**ADDENDUM  
NO. 3**

**September 30, 2025**

**VALE FACILITY ADDITION/RENOVATIONS AND  
MAINTENANCE/IT FACILITY PROJECTS**

**Addendum Three (AD.03)** to the drawings and specifications prepared by Gibraltar Design for **Valparaiso Vale Facility Addition/Renovations and Maintenance/It Facility and Related Work** for Valparaiso Community Schools, Valparaiso, Indiana.

© GIBRALTAR DESIGN SHEET  
**A-101**

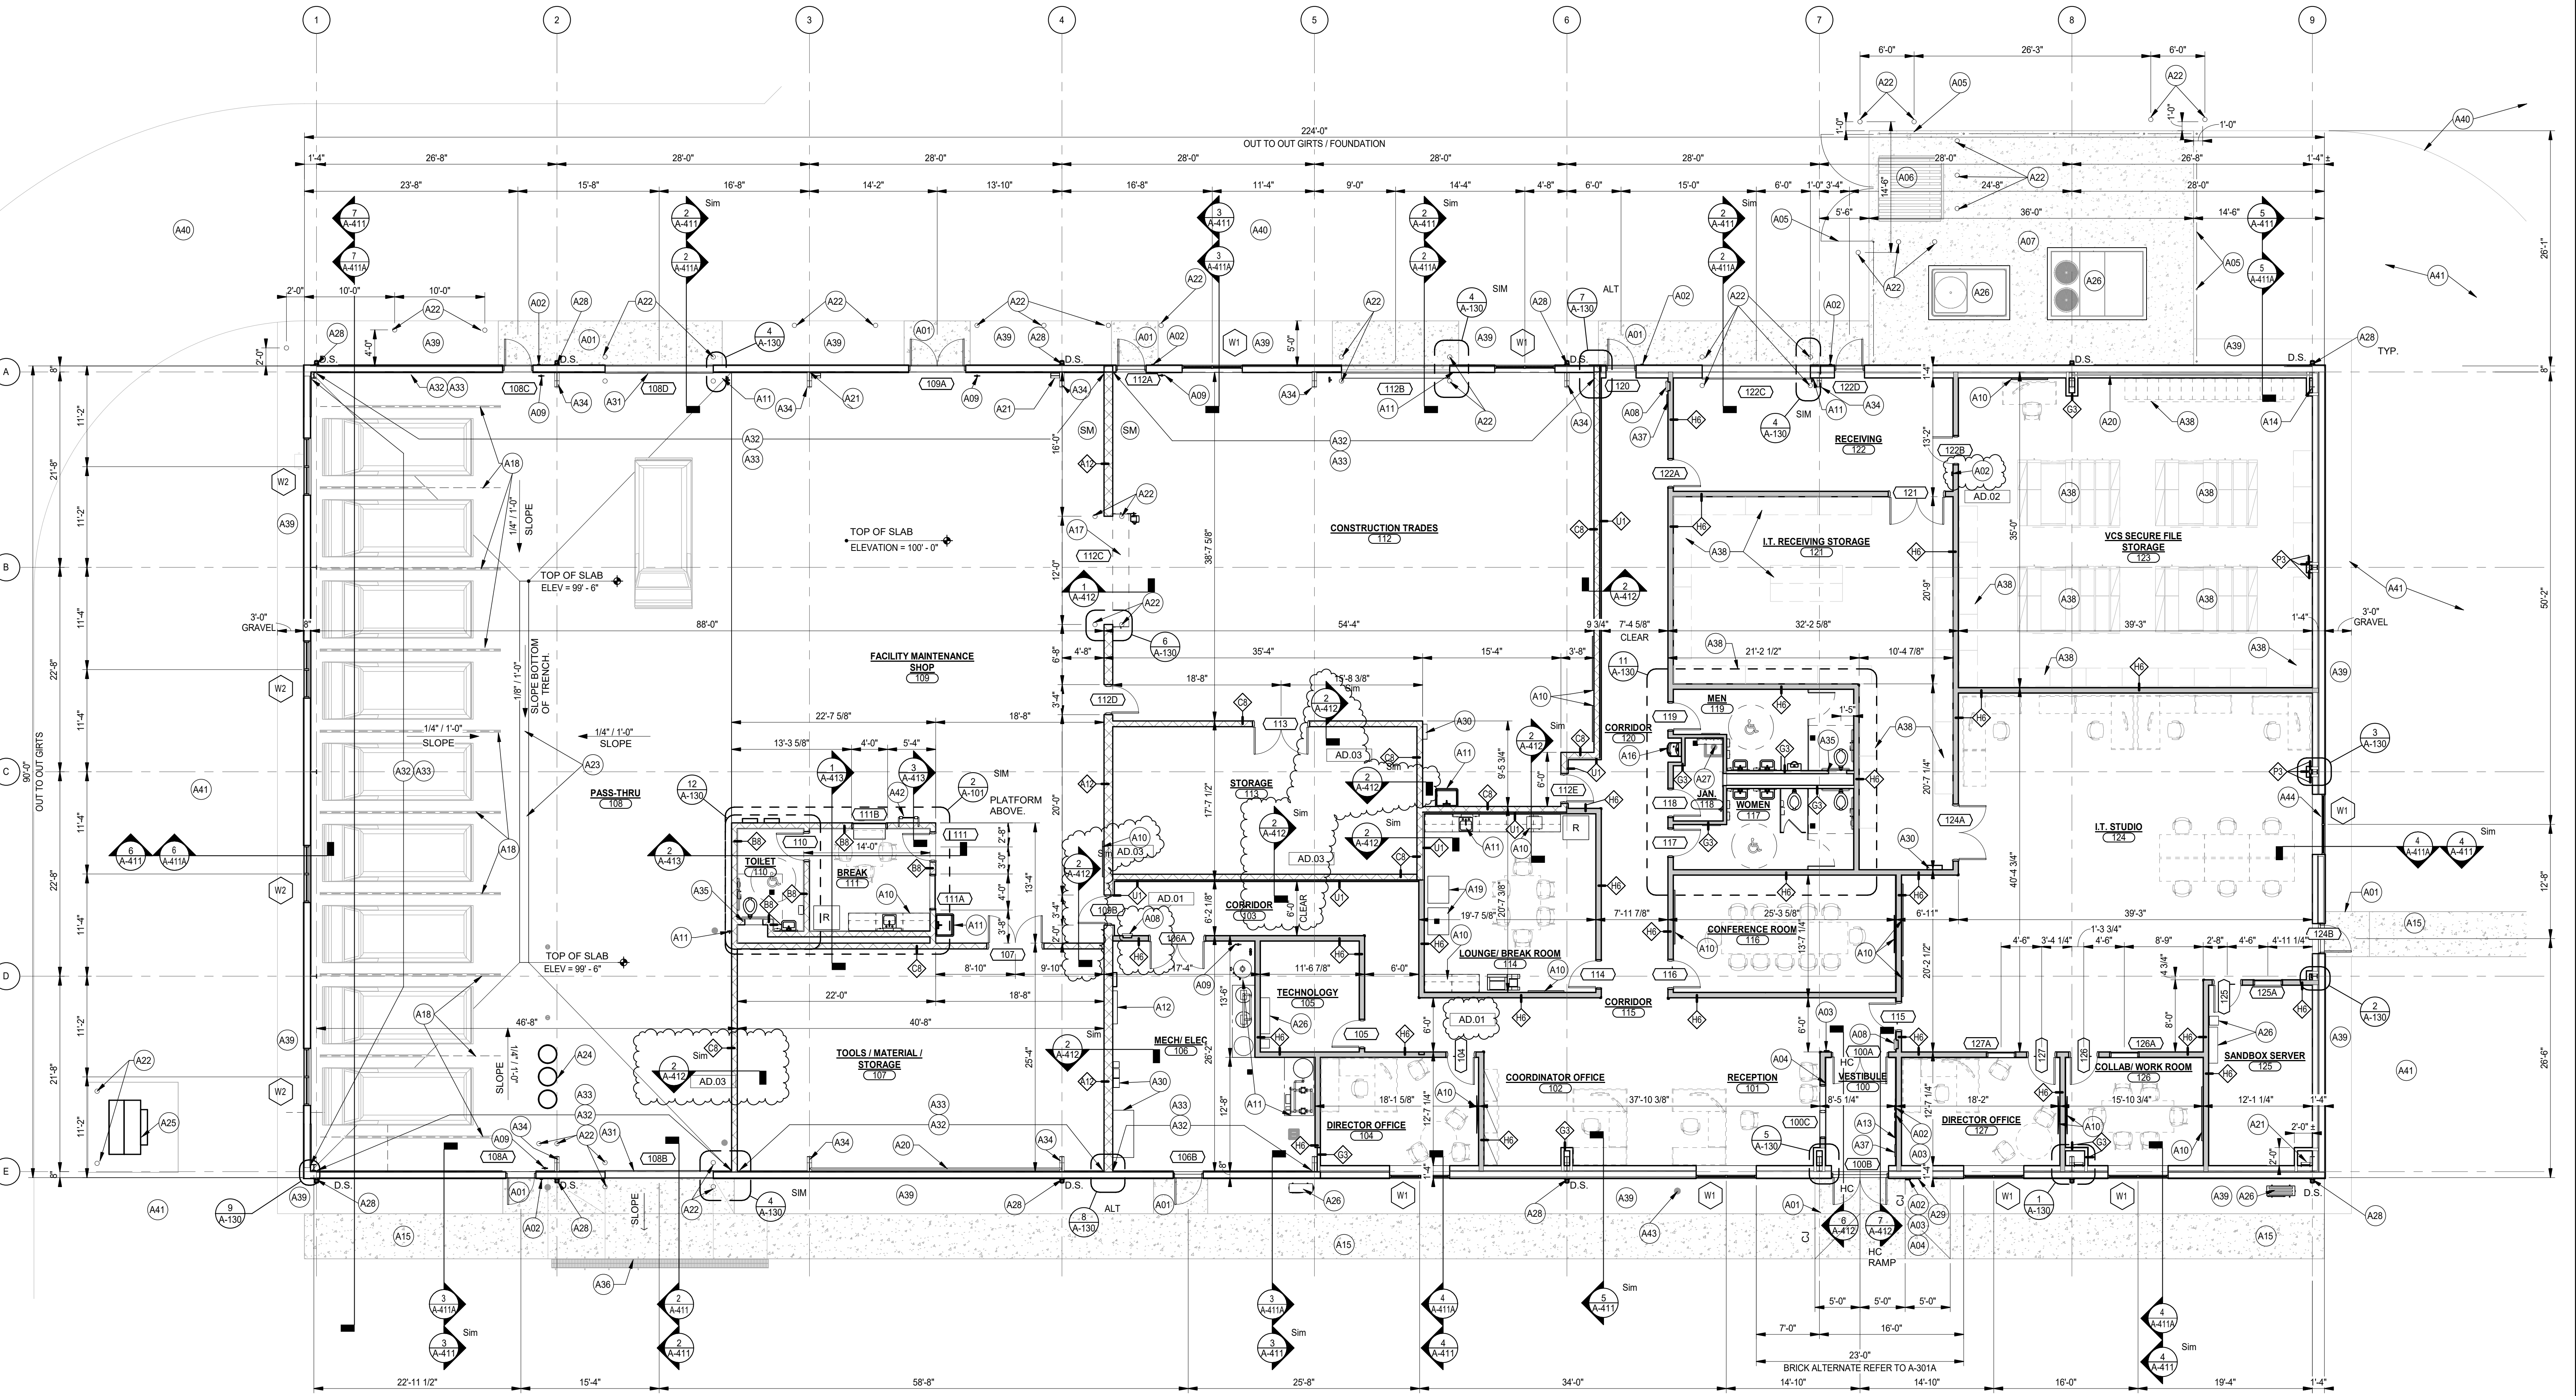
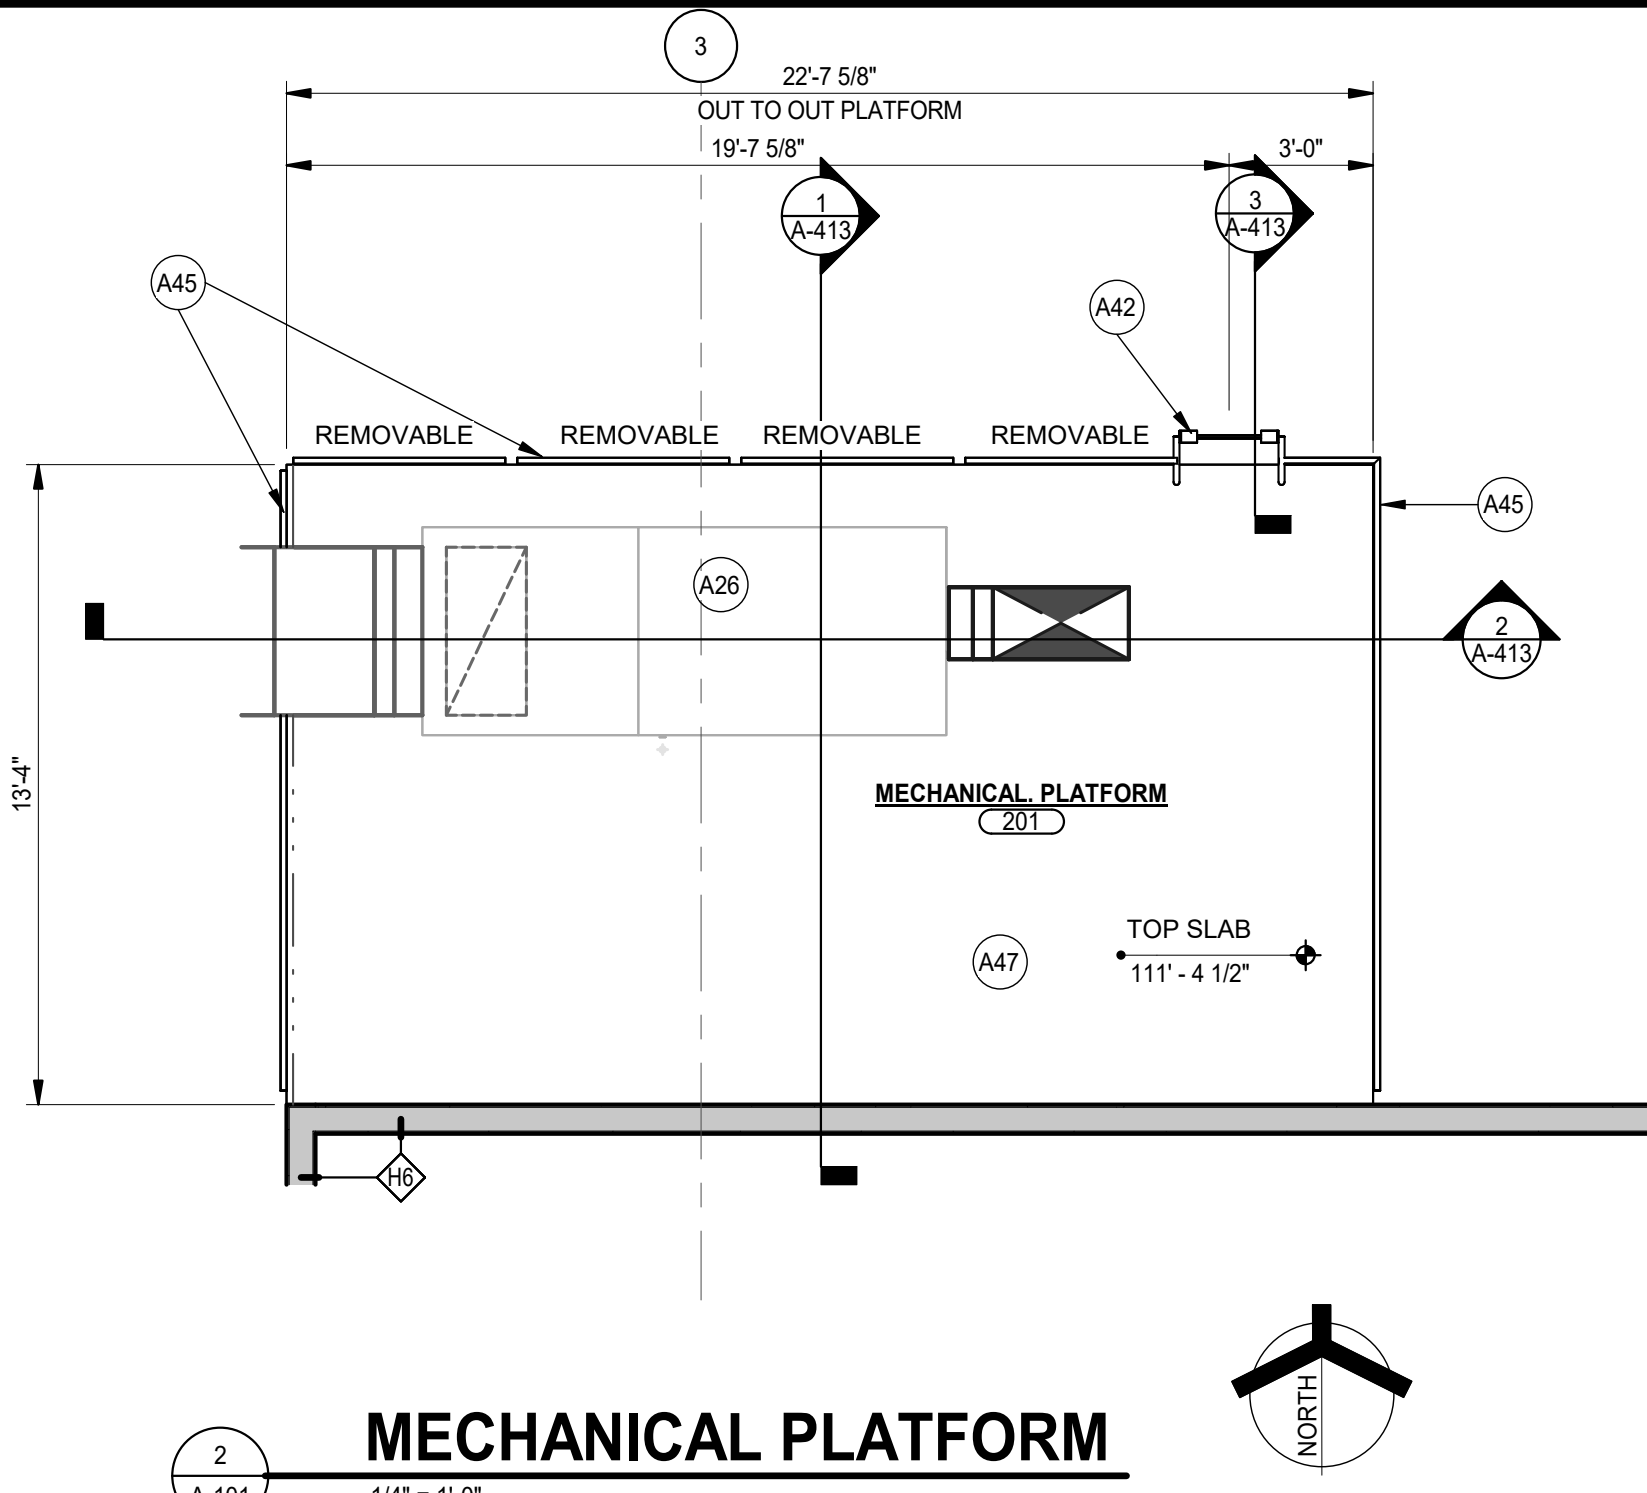
1. Added wall section tag.

**HSS TYPICAL COLUMN BASE PLATE SCHEDULE**

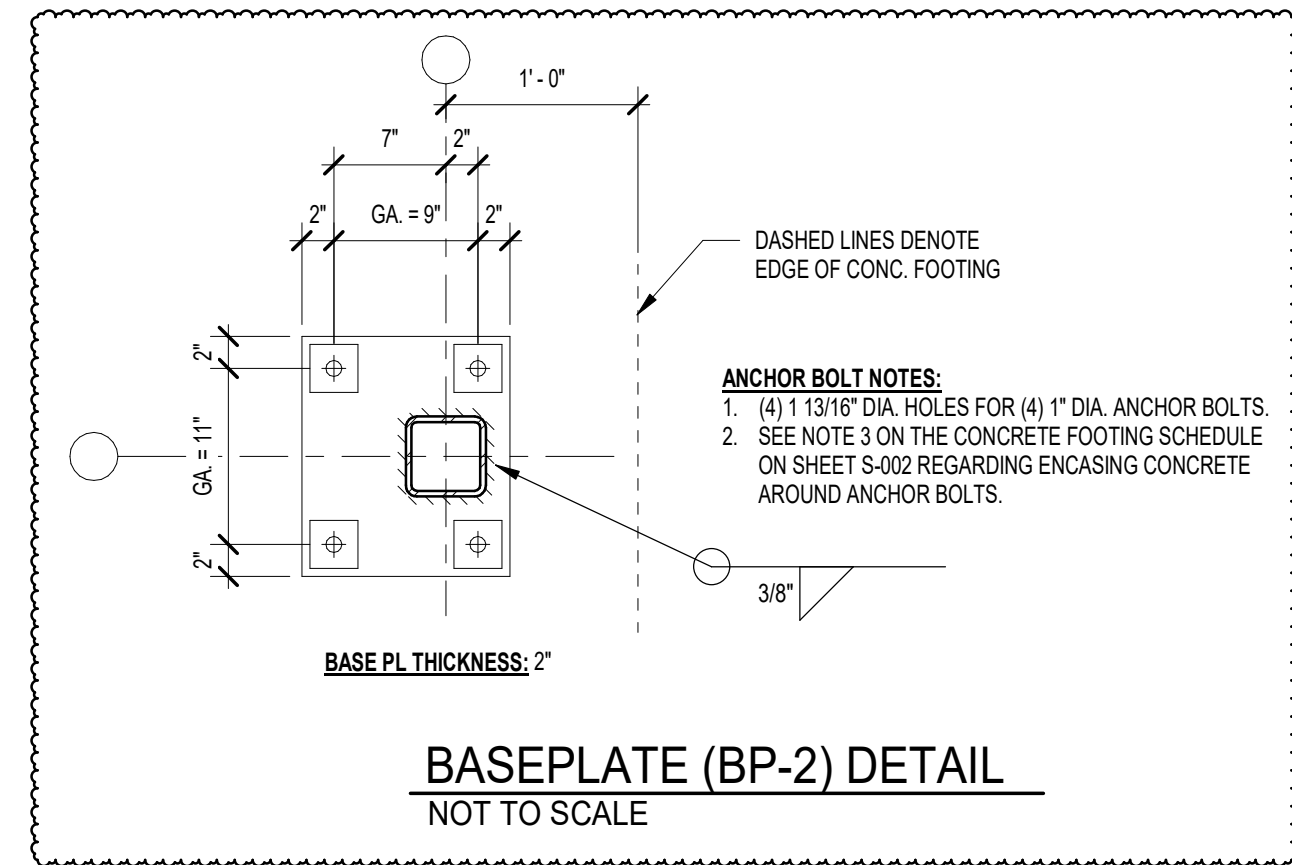
1. Baseplate Schedule Modified.
